Suhde Scale	1:100		Projekti Project	CCGS ANN HARVEY		Kok.paino Total weight	Kg	
Arkkipikoko Sheet size	A3		Asiakas Customer	ABB OY MARINE & PORTS		Liittyy Included in	PHASE A-H	
	Date	Name	Otsikko Title	ORIENTATION				
Suunnittelija Designer	18.5.2018	WiSi						
Tarkastanut Checked								
Hyväksynyt Approved								
			Nro. No.	4000116-5000		Rev.	A	
CAD-tunnus CAD-code			Sijainti Location			Sivu Page	1 / 1	
This document shall not be presented or given to a third party without permission of REJLERS OY !								
Tätä asiakirjaa ei saa ilman lupaa esittää eikä luovuttaa kolmannelle osapuolelle ilman REJLERS OY:n lupaa!

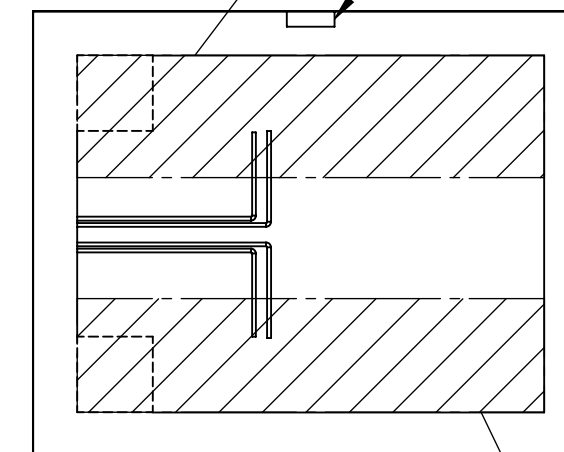
Cabinet seen in picture #1105 to be removed

Converters to be placed in this order according to drawing #3AFV6213 2000 S001

Converters to be placed in this order according to drawing #3AFV6213 2000 S001

Leakage tray is to be placed under converters A1 and A2
